Memorandum

Subject: Resolution No. R-967-19: Report Analyzing Potential Impacts to Miami International Airport from Proposed Development on the International Links Melreese Country Club - Directive No. 192075

EXHIBIT A

Airspace and Land Use Impacts from Proposed Miami Freedom Park Development

Figure 5: Miami-Dade County Zoning Land Use Compatibility Restriction Zones
 75 DNL Zone and 65-74 DNL Zone

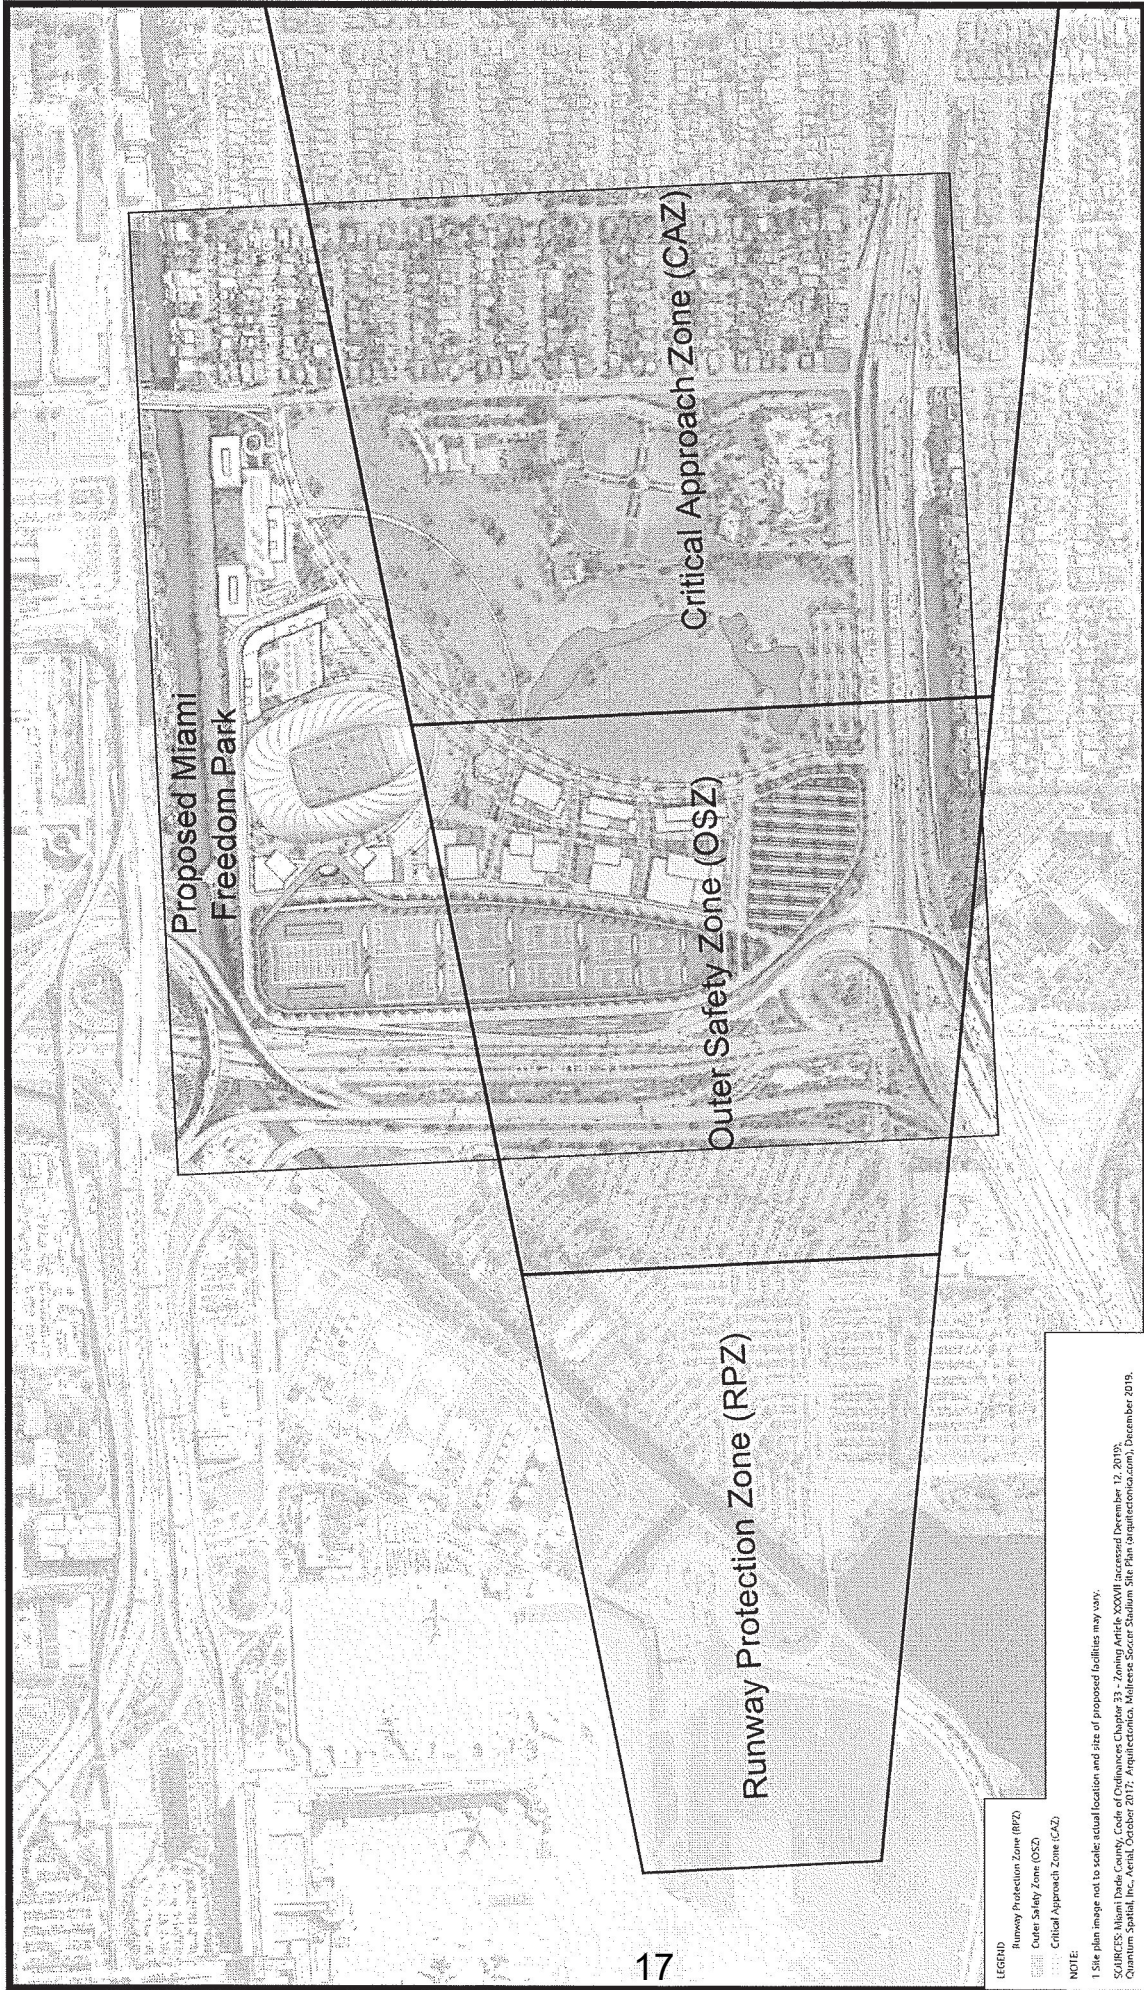
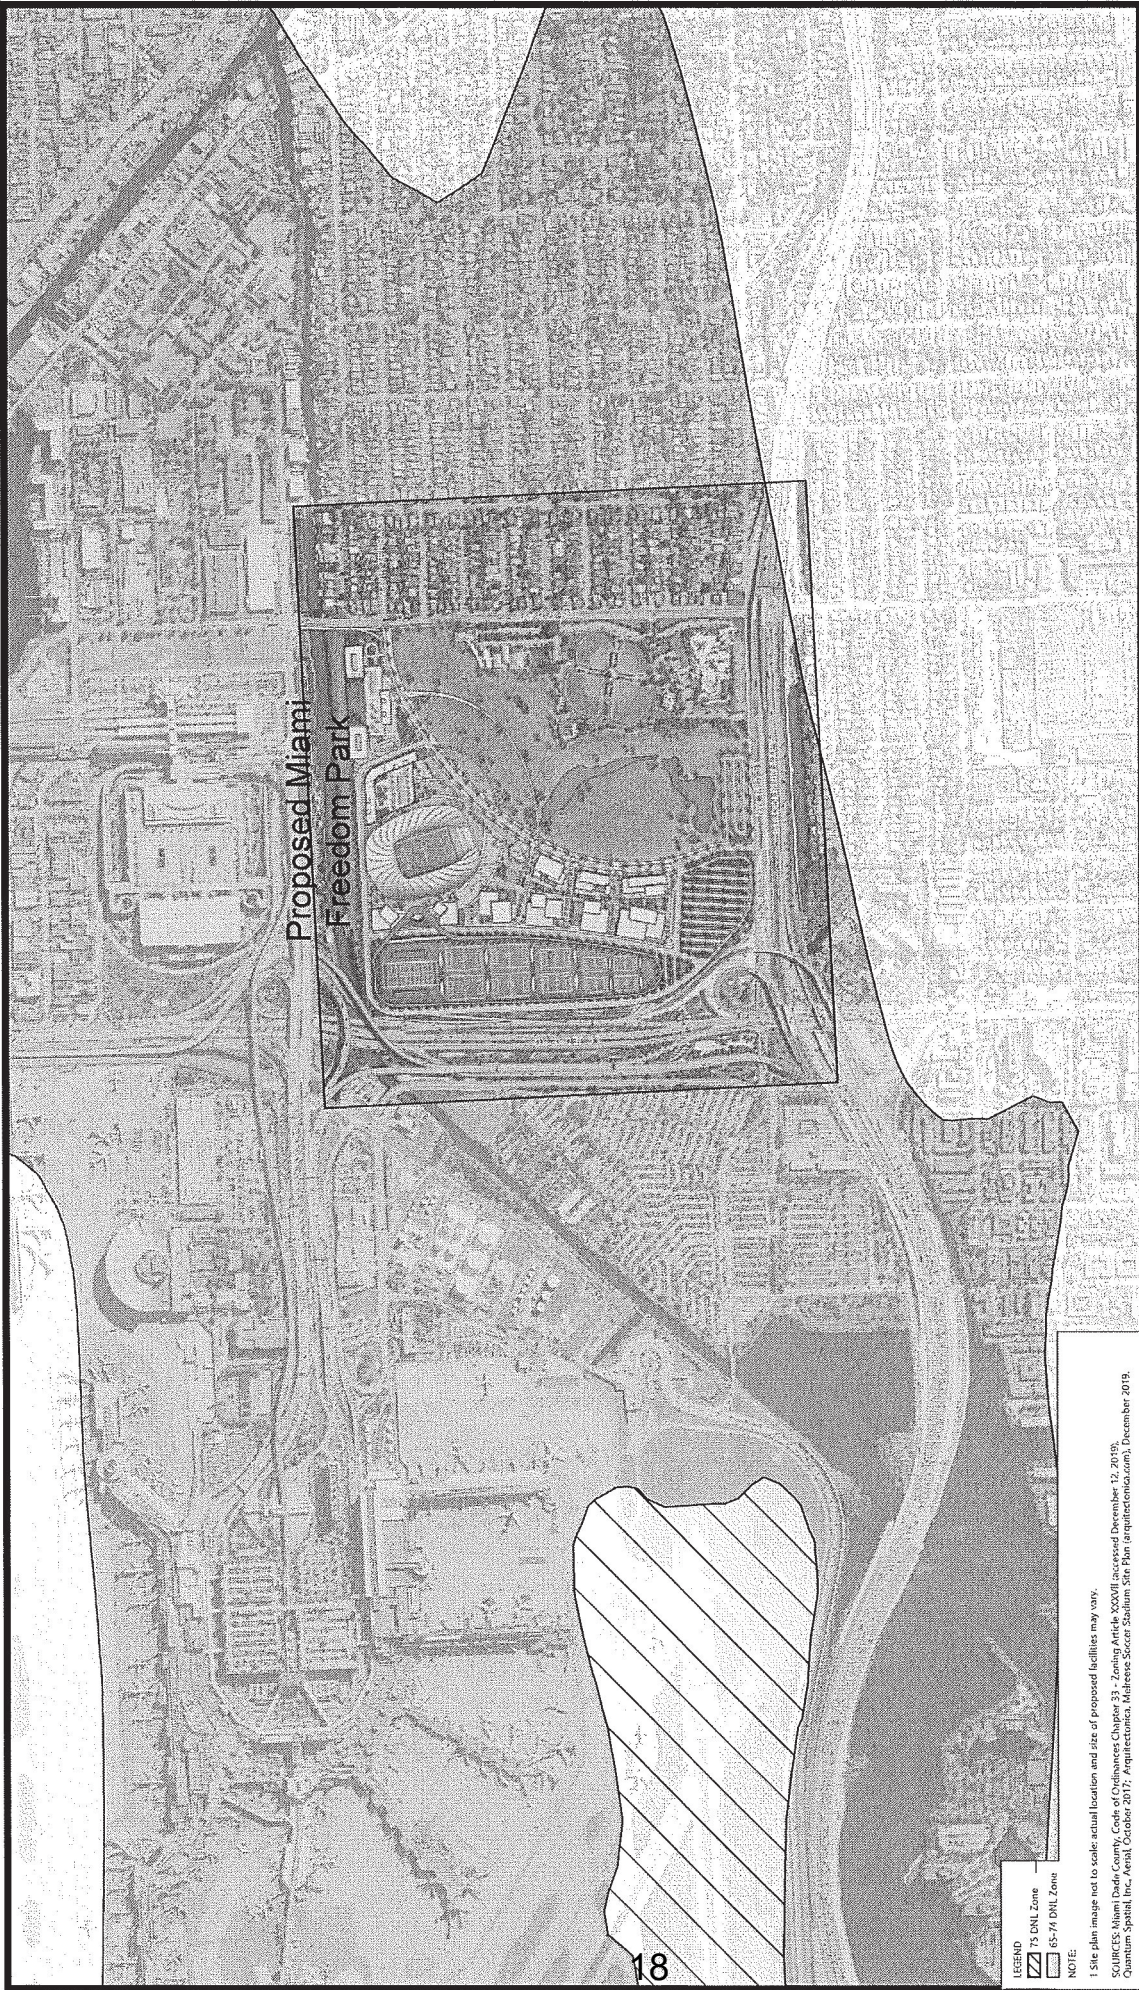
As shown on **Figure 5**, the site is fully contained in the 65-to-74 DNL Noise Compatibility Restriction Zone. The 65-to-74 DNL Zone is a contour depicting concentrations of aircraft noise around an airport based on day and night noise levels averaged over a year at 65-to-74 decibels. All new uses shall incorporate at least a 25-decibel outdoor-to-indoor Noise Level Reduction (NLR) into design and construction. This means that any development on the Melreese parcel must include the required noise reduction elements mandated by the Code.

Figure 6: Height Restrictions Over Proposed Miami Freedom Park
 Miami-Dade County Zoning - Approach Surface

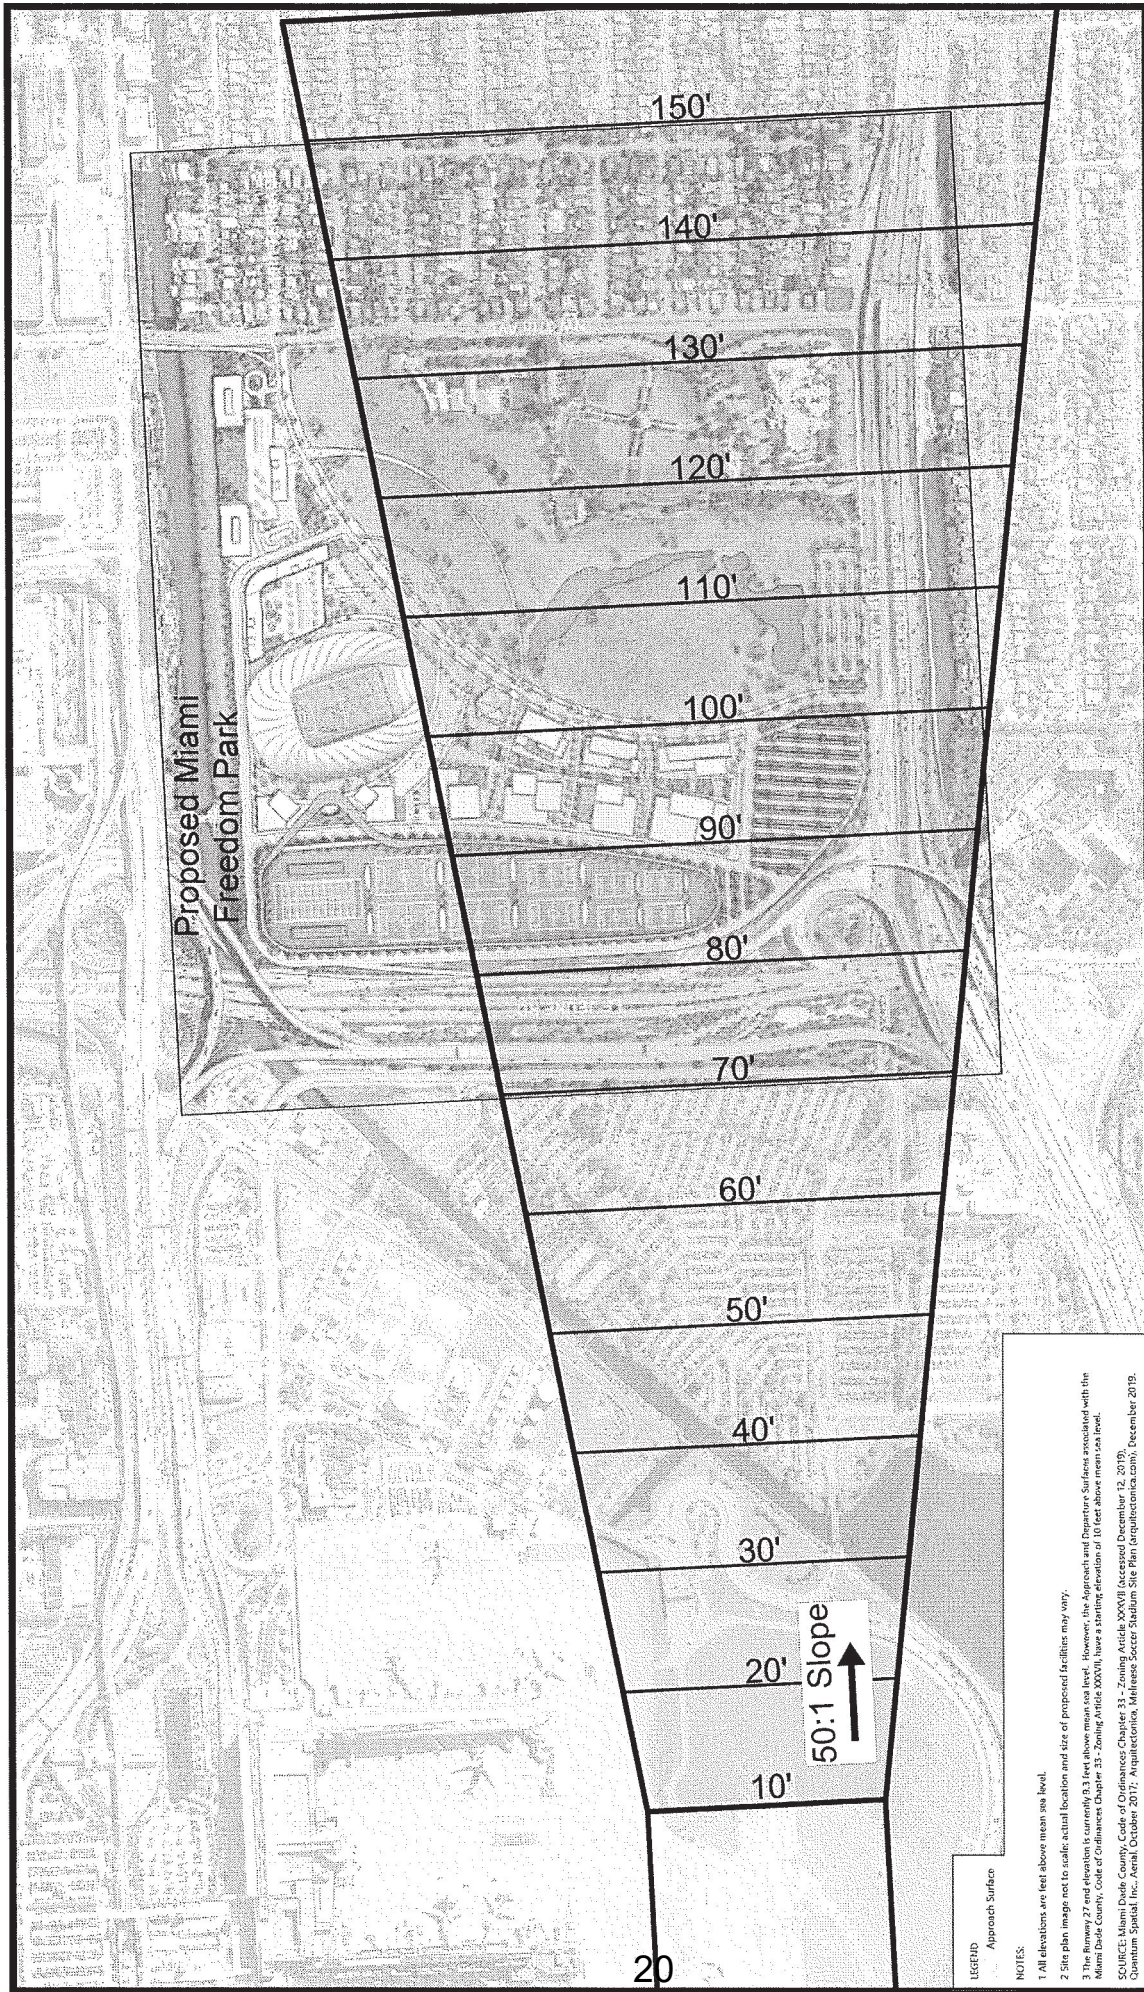
At the time this study was initiated, the developer of the stadium had only provided artist's renderings of the proposed stadium, and not actual dimensions for analysis. However, on December 3, 2019, Capitol Airspace Group submitted eight points (GPS coordinates), along with an architect's profile elevation drawing as part of a request for a Preliminary Letter of Determination. As mentioned above, MDAD's preliminary analysis concluded that four of the

eight points exceed the height limitations prescribed in the Code. A copy of MDAD's Preliminary Airspace and Land Use Determination Letter is contained in **Appendix B**.

Figure 9: Height Restrictions Over Proposed Miami Freedom Park
 Miami-Dade County Zoning - Composite Airspace Surfaces

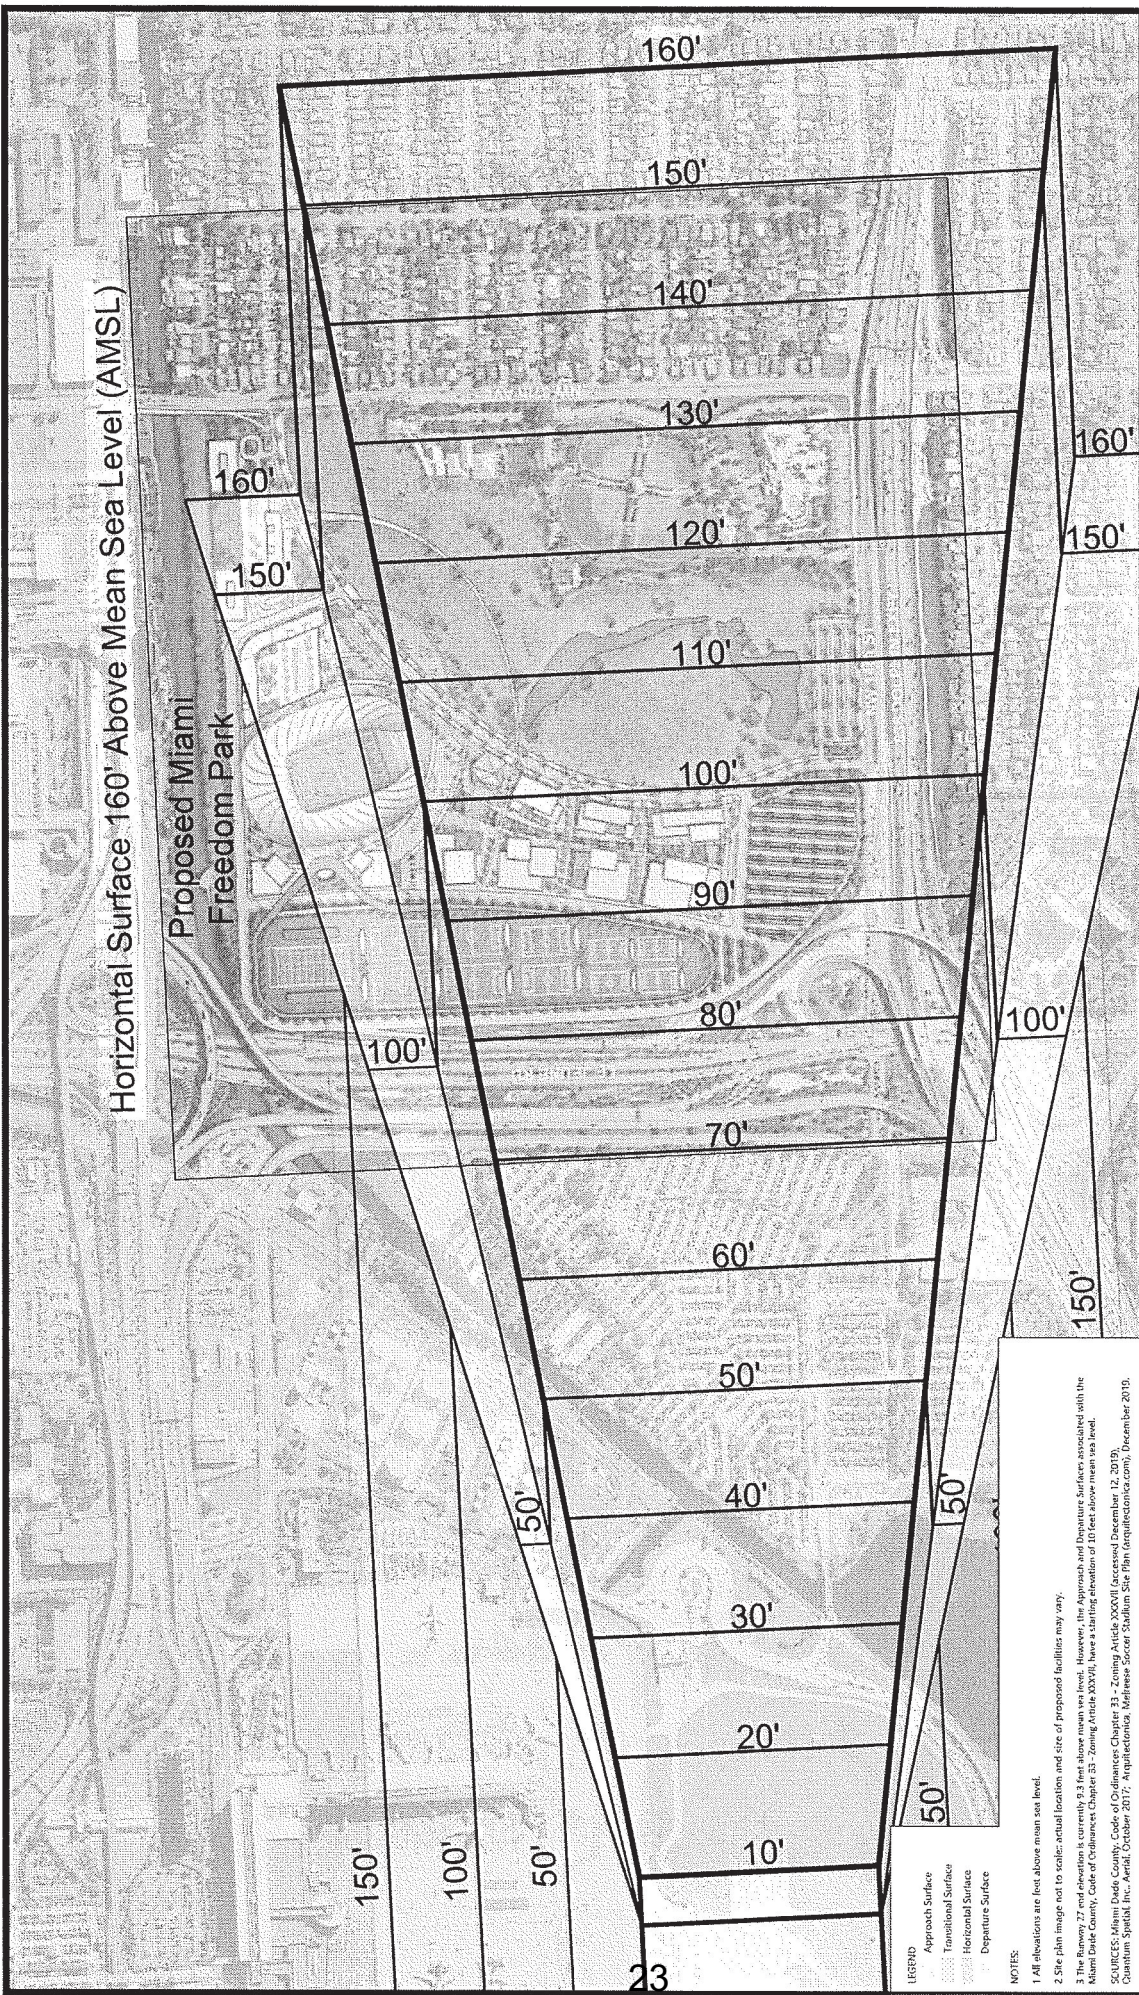
Figure 9 includes a composite illustration of the most restrictive obstacle clearance surfaces that overlie the Melreese parcel. The most restrictive surfaces would result in the lowest permissible heights of structures.

Figure 10 – Proposed Miami Freedom Park's Lighting and Glare Impacts⁷

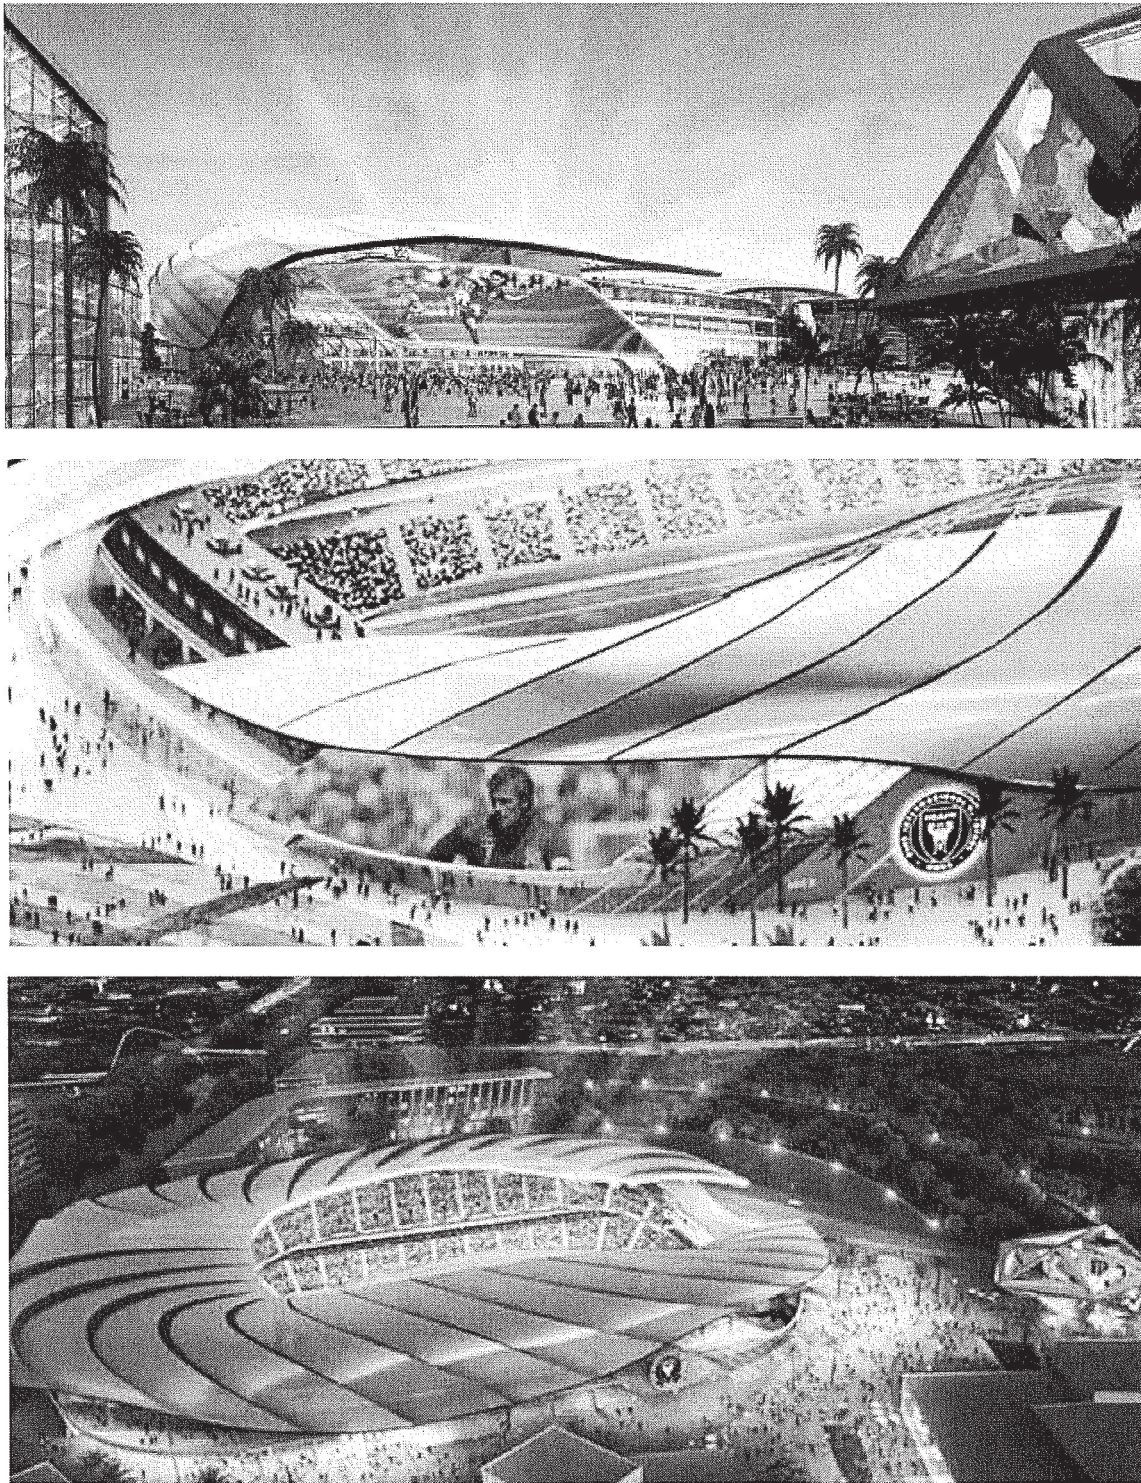
Figure 10 includes a few samples of the artistic renderings that are depicted on the Miami Freedom Park website. These renderings highlight MDAD's concerns with the lighting and glare impacts associated with the proposed soccer stadium, practice fields, and other ancillary facilities. **Figure 11** illustrates the soccer and football practice fields oriented in a north to south configuration along NW 42nd Avenue, which are expected to include field lighting. These lights will create an array of lights perpendicular to the approach and departure path of Runway 9-27.

Aside from the safety issue of potentially impairing a pilot's vision by bright lights while on final approach, the lighting and glare concerns resulting from the construction of a stadium on the Melreese parcel may also affect airfield capacity. As described above in the Air Traffic Control section of this report, the flow of air traffic is dependent upon many issues. Accommodating pilot requests for runways other than Runway 27 due to the glare from stadium lights would impact the capacity of the airfield as a whole.
